TECHNICAL RESPONSE TO HCC HIGHWAYS COMMENTS

Ridge and Partners have been commissioned to respond to the Road Safety Audit undertaken by Fenley (March 2026) as part of the S278 Technical Approval Process.

Road Safety Audit Report

Proposed Continuation of Coldharbour Farm Road Emsworth

DISCLAIMER NOTES:

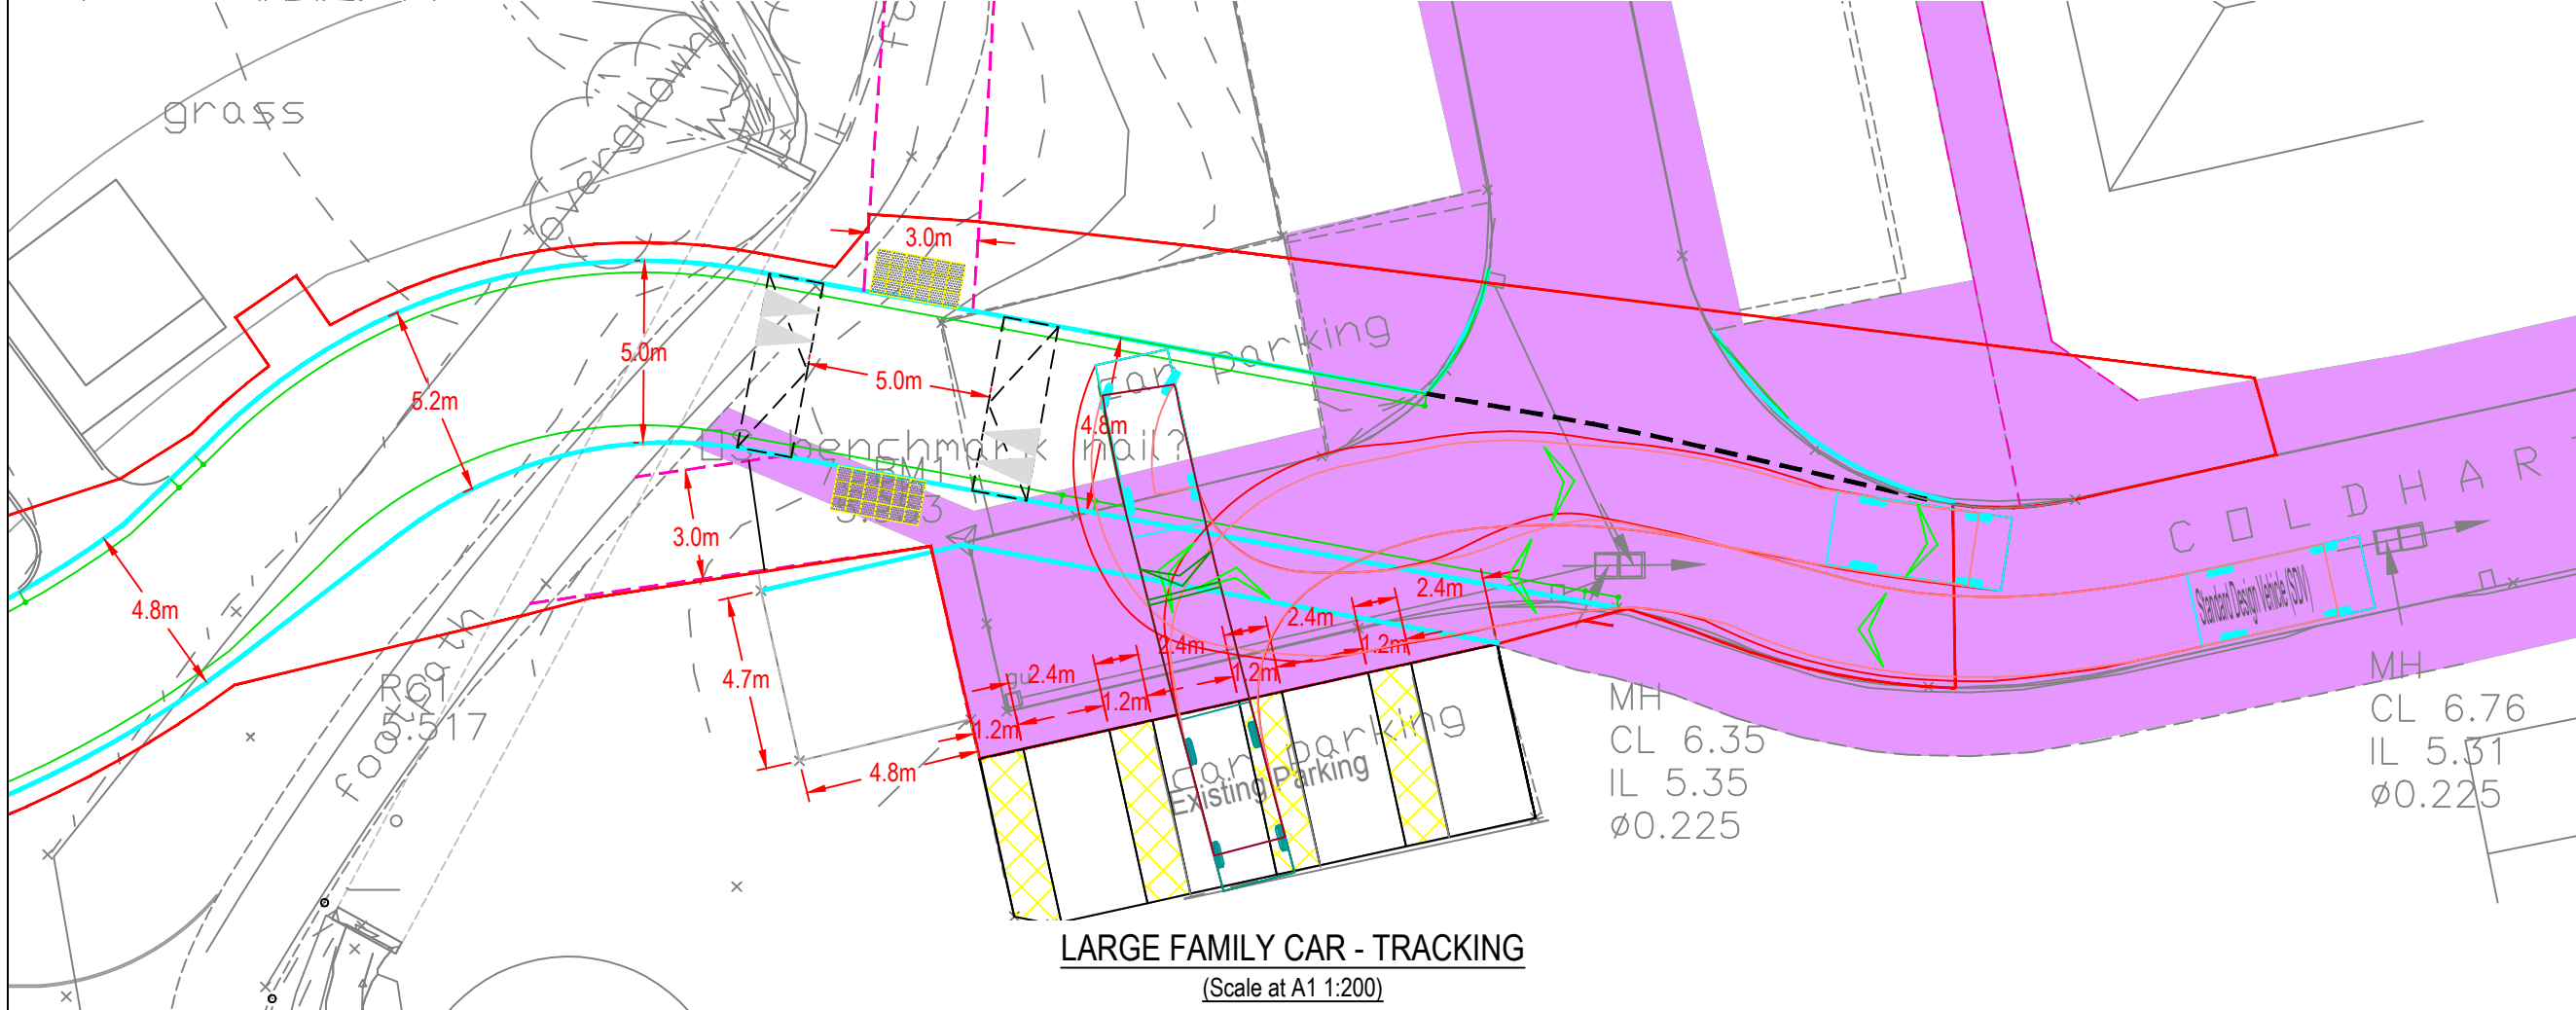
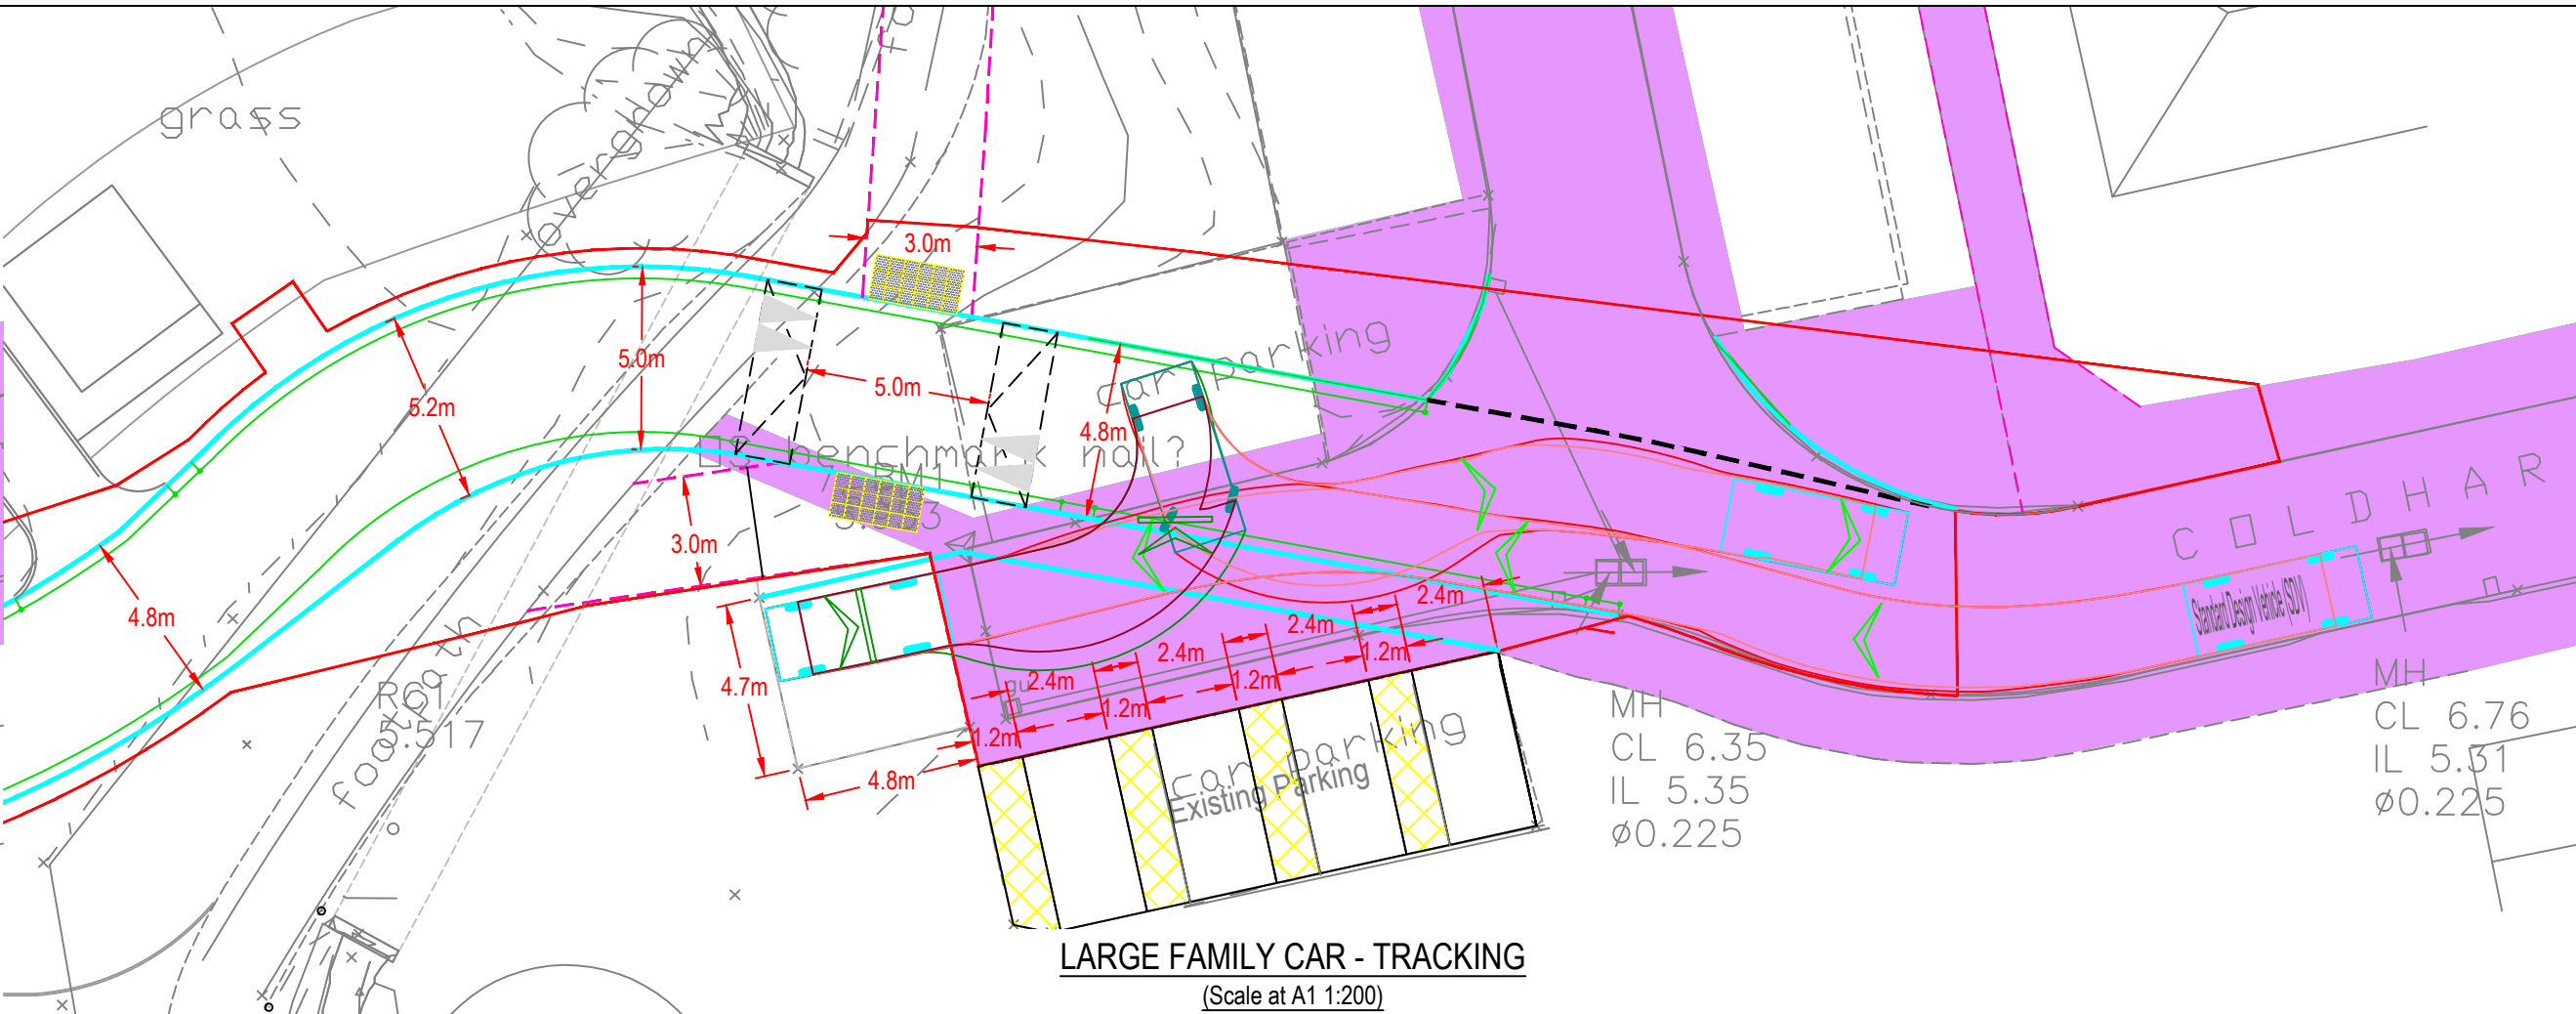
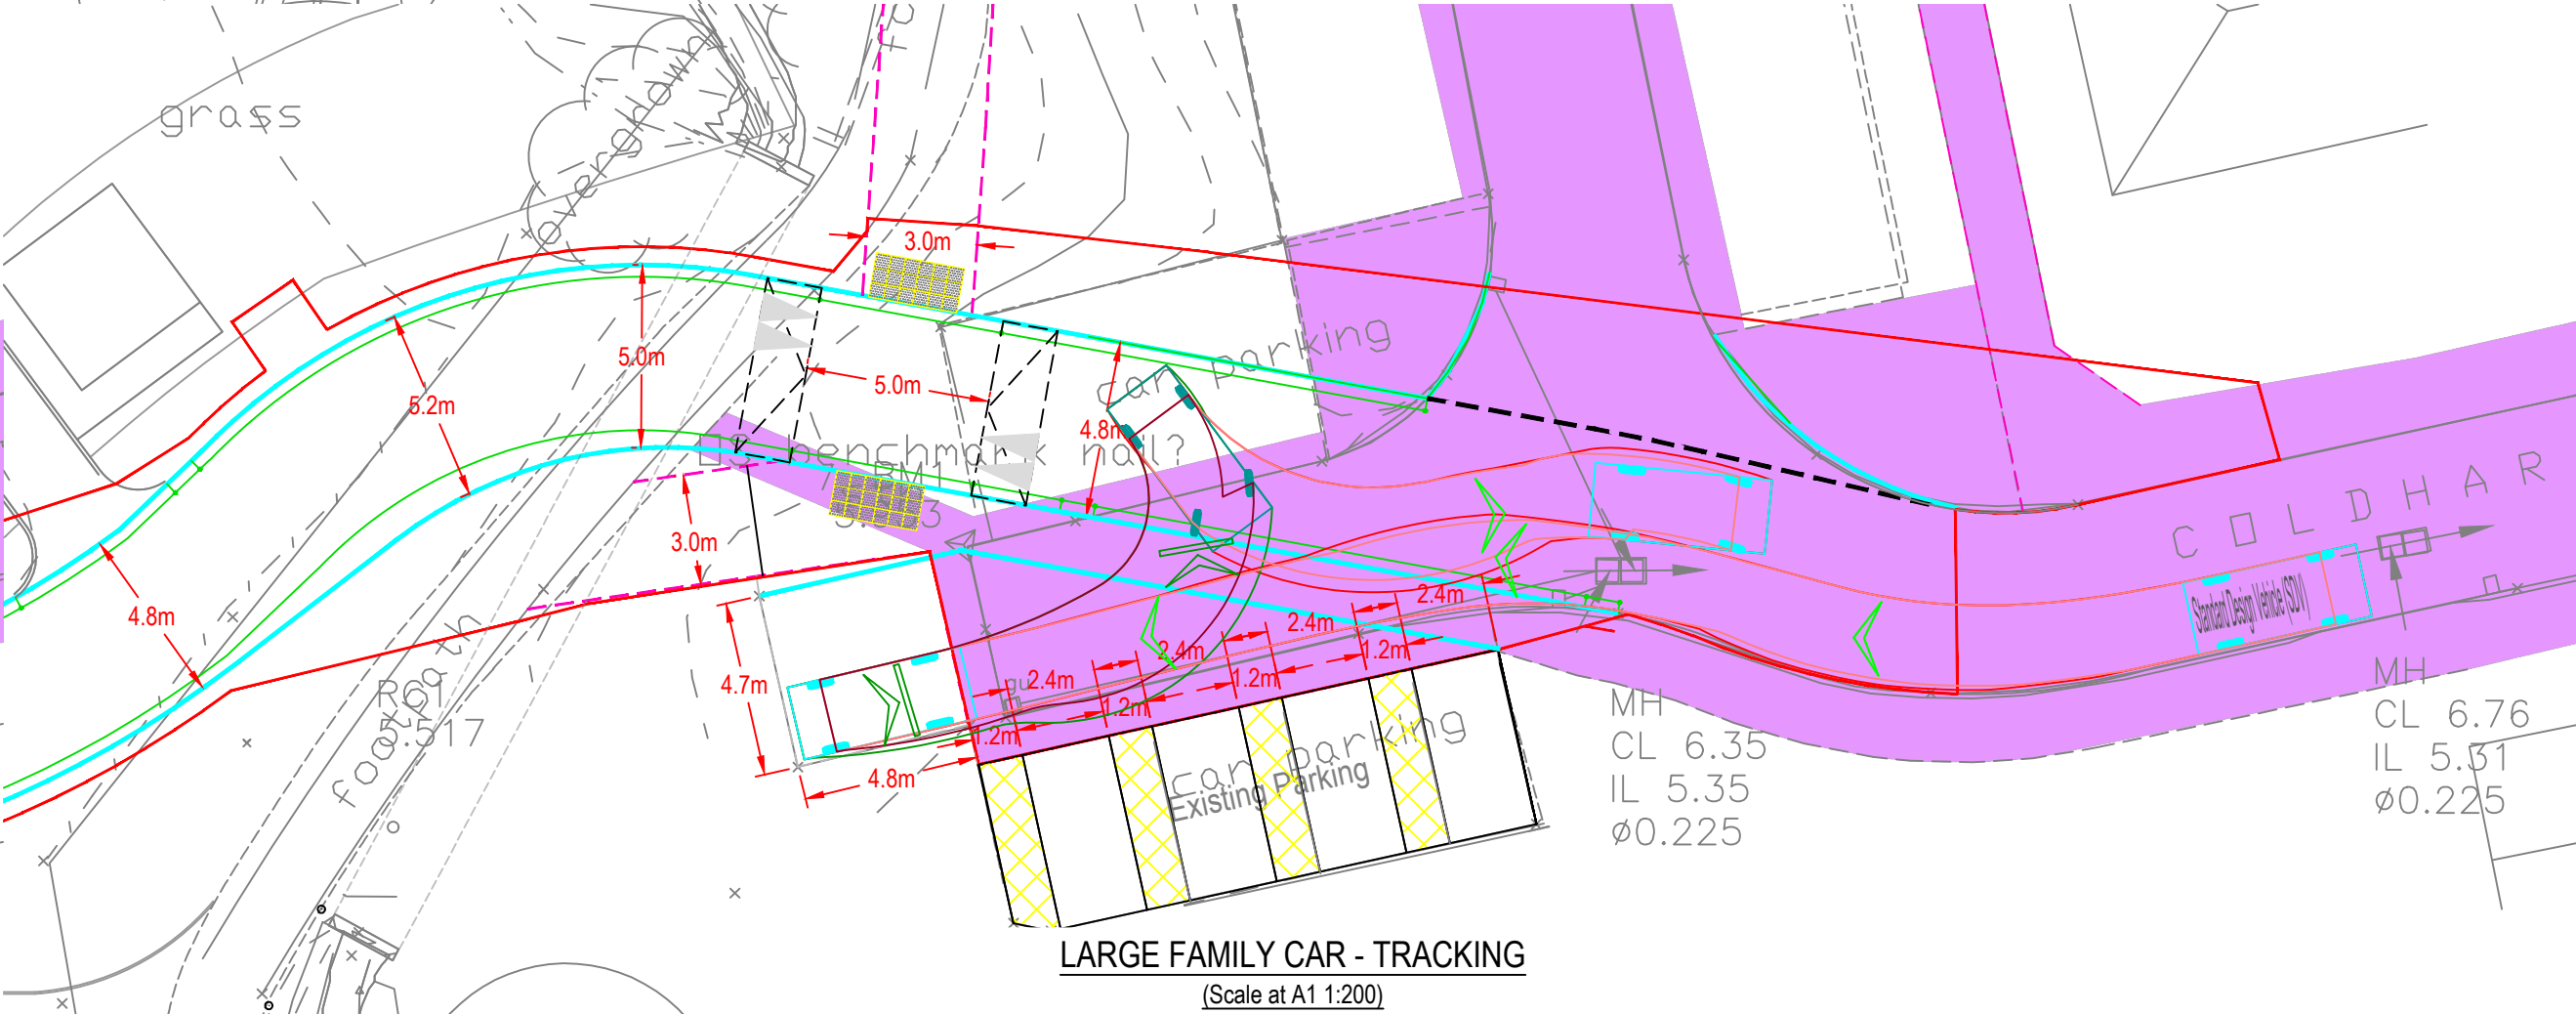
B2.2 Vehicles may not be able to access the existing parking bays. It is recommended that the bays are accessible.

The existing parking bays are proposed to be relined as shown on Drawing 23339-JUBB-XX-XX-DR-X-000100 REV C13 and the tracking is shown on Drawing 23339-JUBB-XX-XX-DR-X-001203 REV C1.
